Job No. 21-13556

Subject: **Addendum to the Report of Preliminary Geotechnical Investigation and Geologic Fault Investigation and Response to the City of San Diego Geotechnical Review**
Proposed Javaheri Residence
2072 Via Casa Alta
La Jolla, California

City of San Diego Development Services Department, 2023, LDR-Geology Cycle Issues, Project No. 698915 – L64A-0003B.

EXPLORATORY TRENCH T-1
East Side Wall

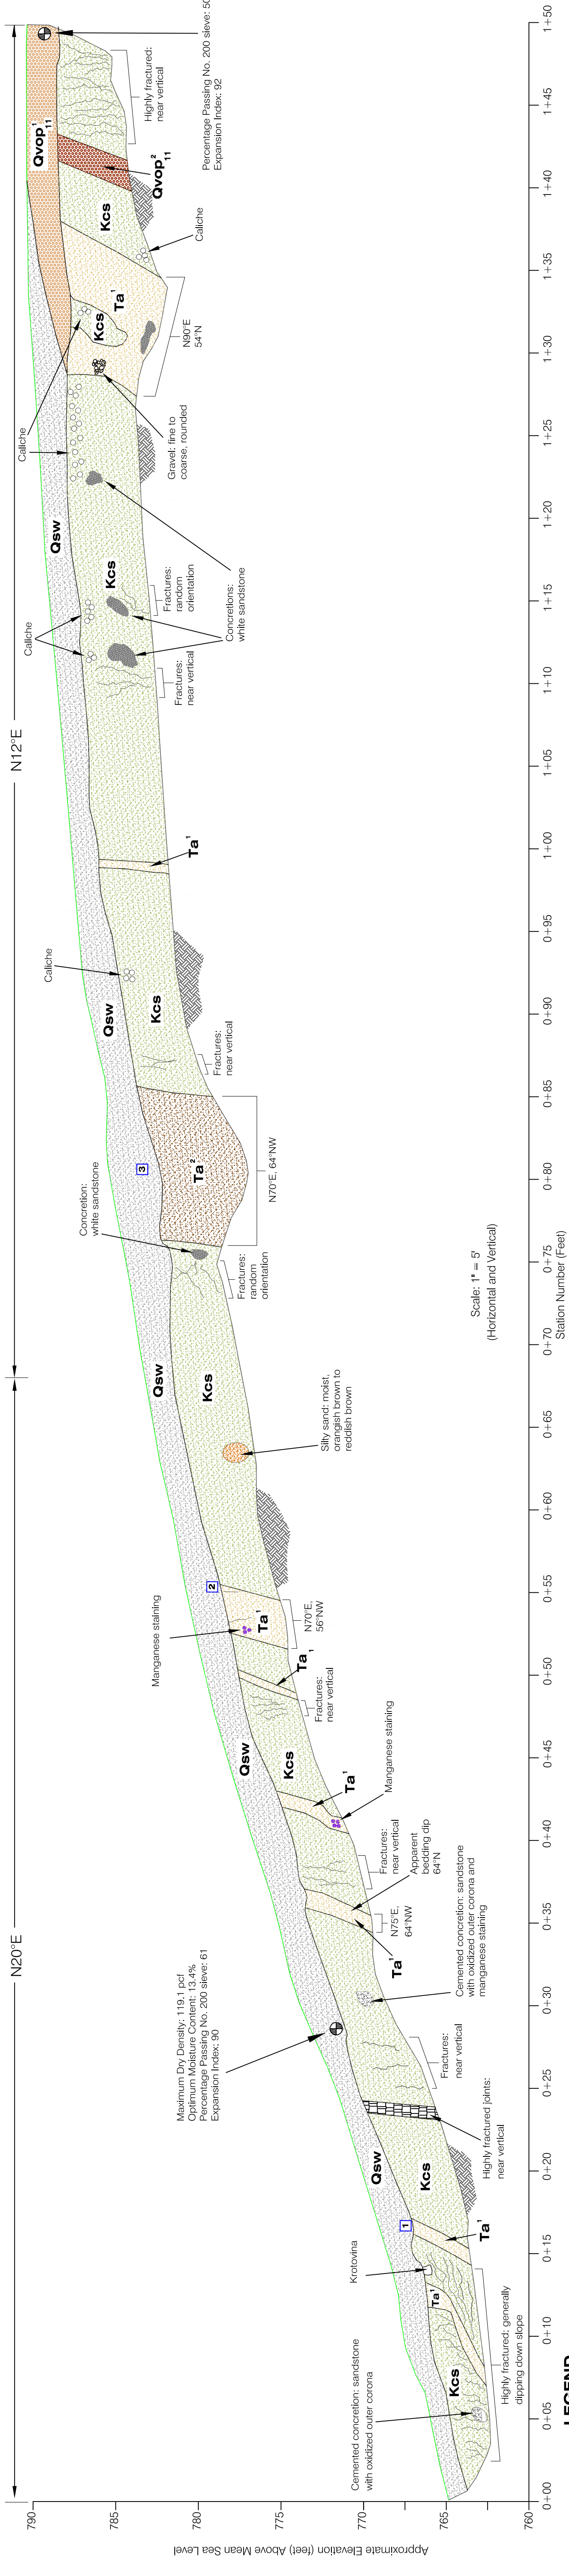
Issue No. 23: *Provide a revised Exploratory Trench T-1 log and remove all references to Geologic Cross-Section A-A'. Those references appear to be inaccurate and are confusing. The project's geotechnical consultant could consider simply labeling the trench limits with North and South. (New Issue)*

Response: Attached as Figure No. III is a revised Exploratory Trench T-1 log with north and south labeling and no reference to geologic cross section A-A'.

SLOPE STABILITY CALCULATIONS WITH SLIDE 6 COMPUTER PROGRAM

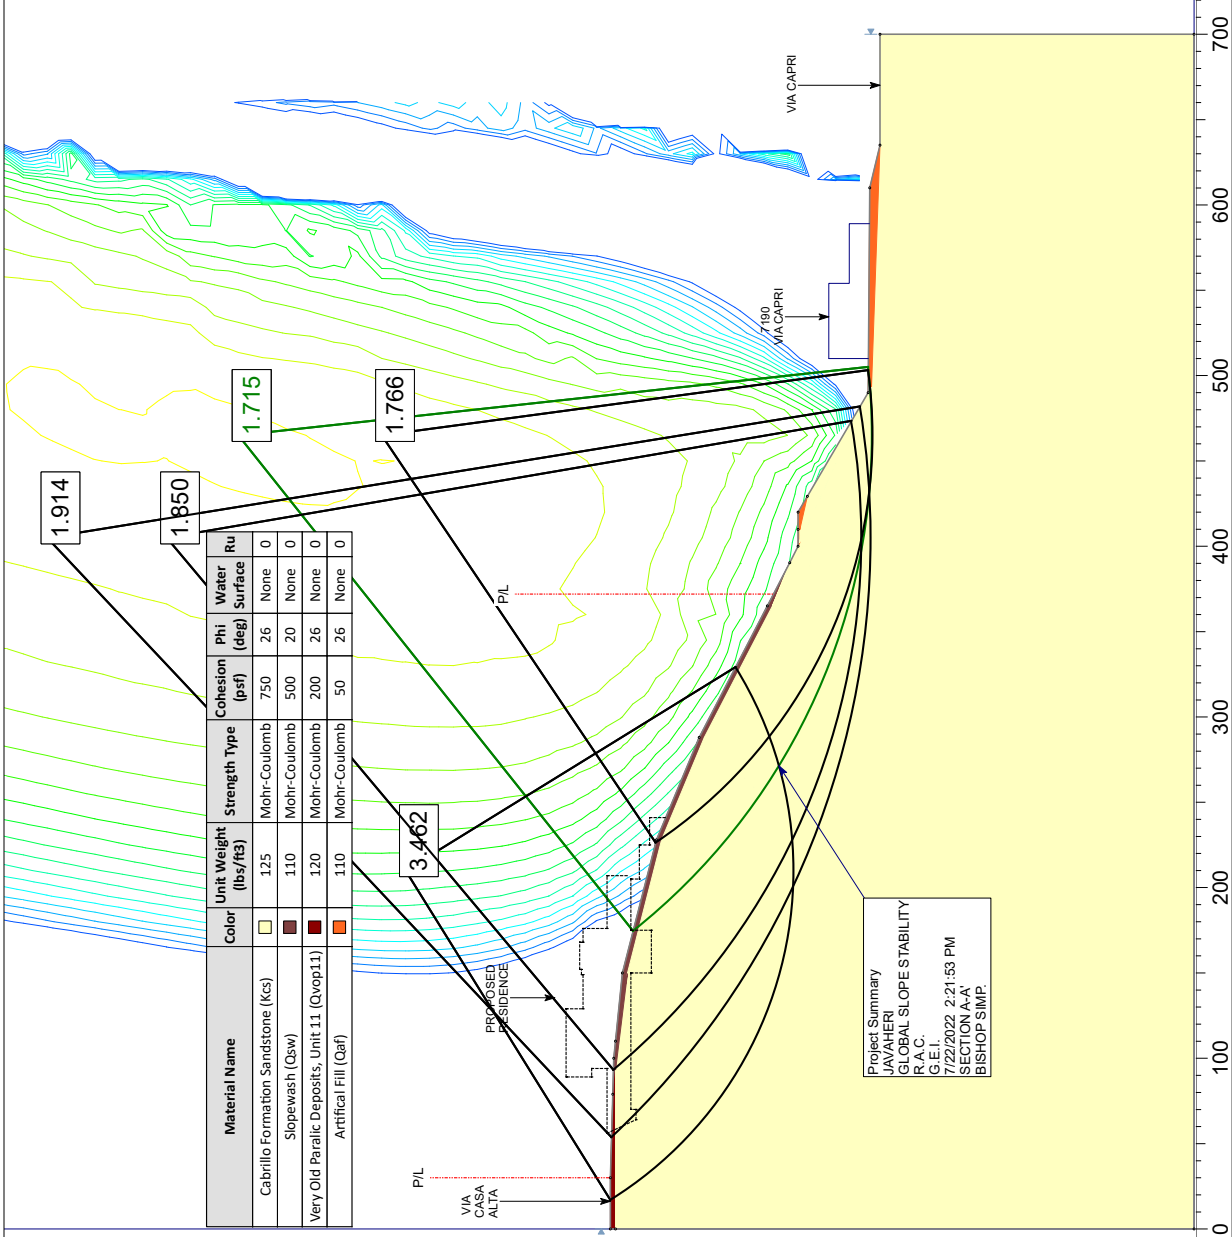
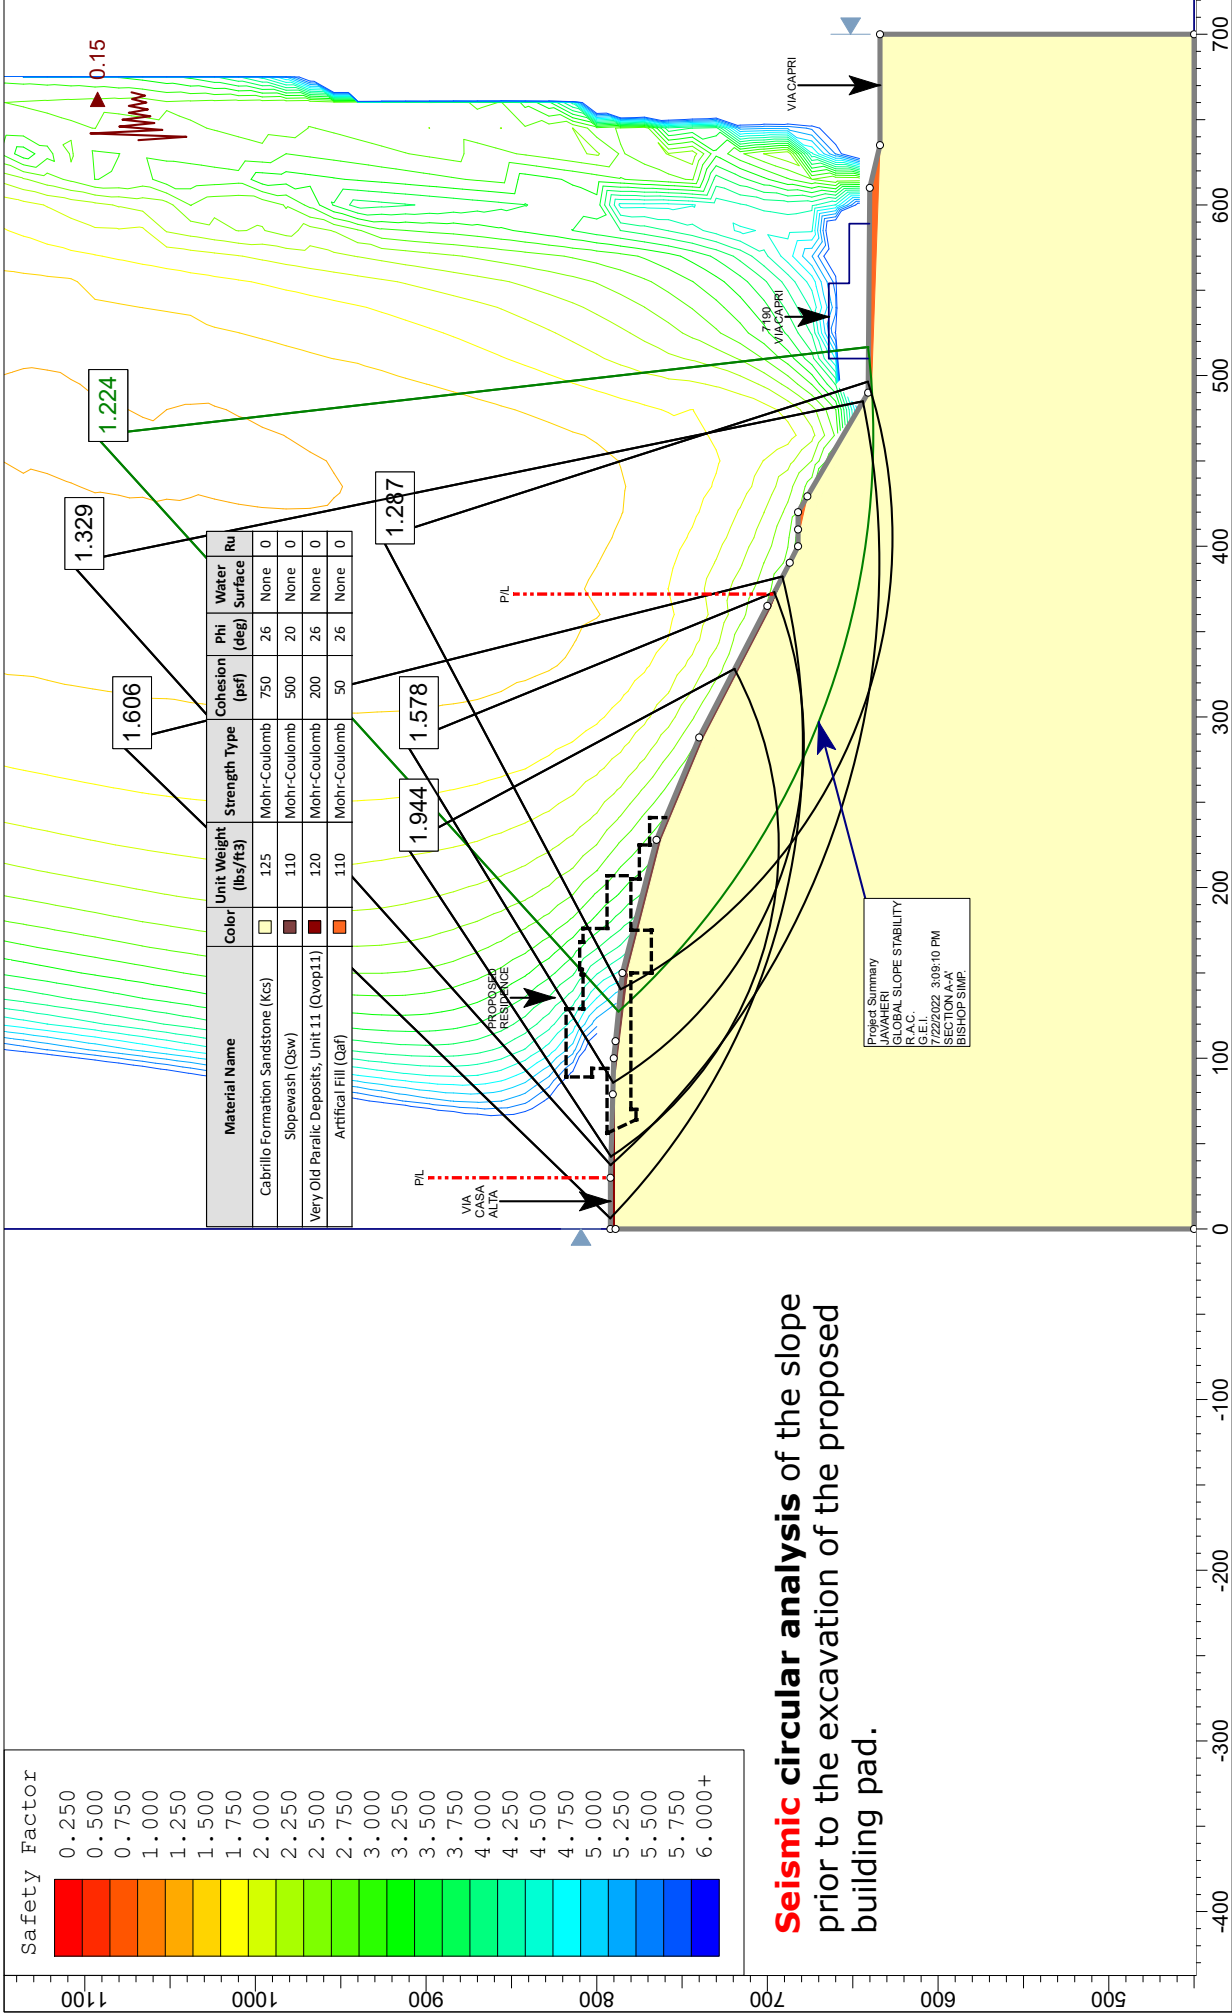
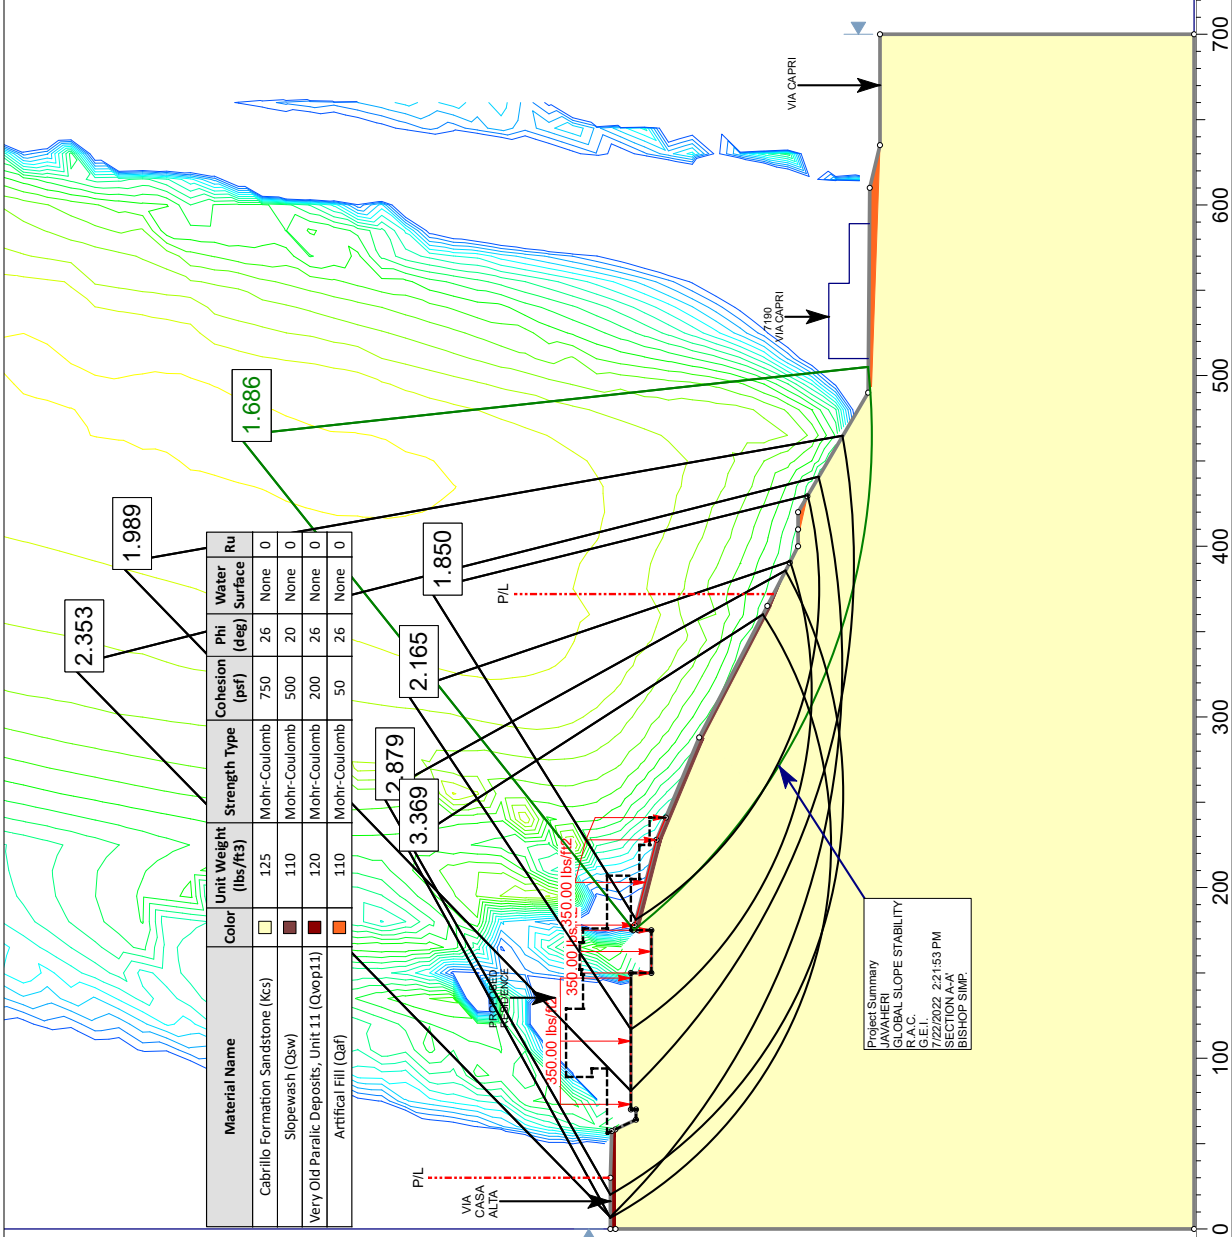
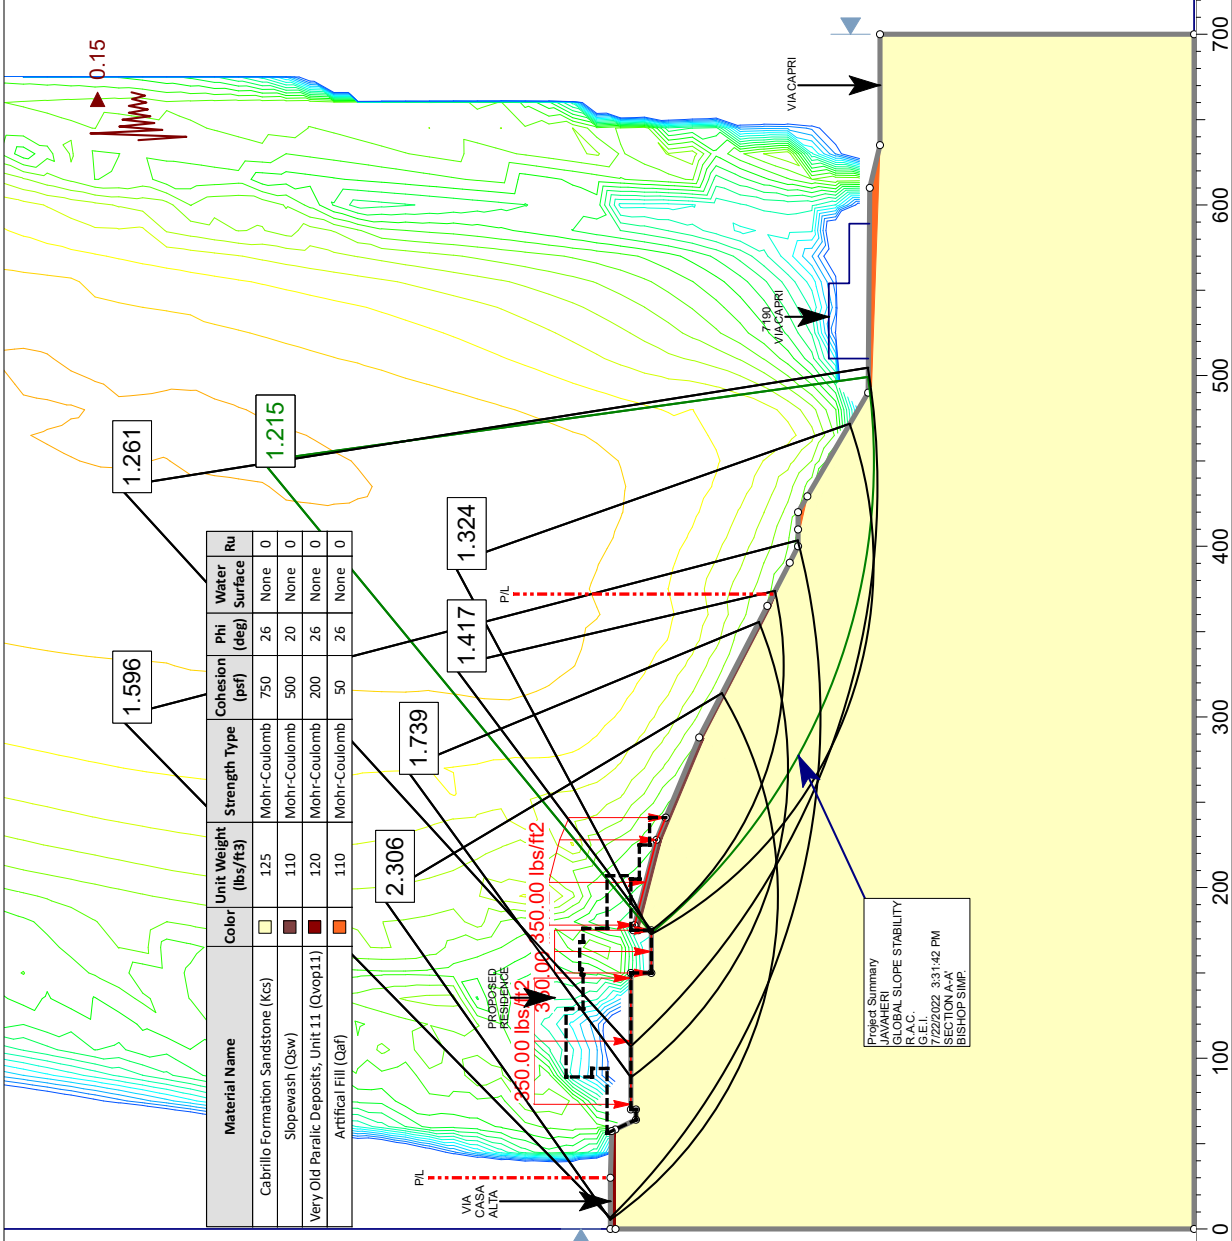
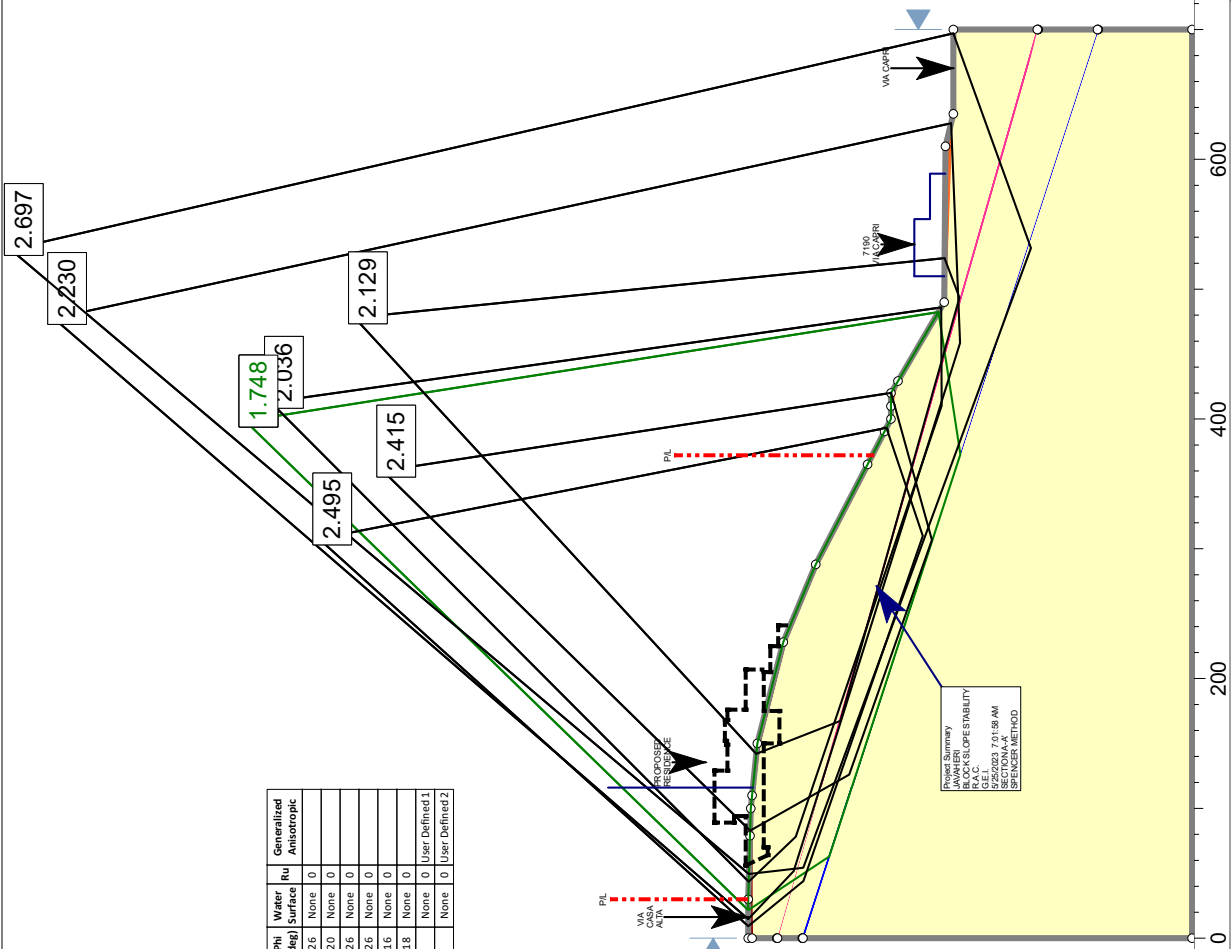
Issue No. 9: *Demonstrate the site will have a factor of safety of 1.5 or greater with respect to gross and surficial slope stability following completion of the project. Provide slope stability analyses consistent with the geologic cross sections. (From Cycle 2)*

Issue No. 24: *The project's geotechnical consultant should clarify if their stability analysis presented in the submitted report included site-specific bedding and geologic structure data. As per the City's Guidelines for Geotechnical Reports, describe the stability analysis and discuss the results. The description should include the method of analysis, specified material profile, and specified search areas for critical failure paths. Where multiple slope stability analyses are conducted, a tabulated summary of the analyses and results should be provided. (New Issue)*

Response: We are providing a slope stability analysis based on cross section A-A' through the site. Based on our revised gross and surficial slope stability analysis, the site has a factor of safety of 1.5 or greater and a factor of safety of at least 1.15 in seismic loading analysis. Refer to attached Figure Nos. I and II for the geologic cross section through the site and Appendix A for slope stability analysis.

Response: The slope stability analysis, presented here as Appendix A, includes site-specific bedding and geologic structure data as well as the method of analysis, specified material profile, and specified search areas for critical failure paths. A tabulated summary of the analyses and results is also provided in Appendix A.
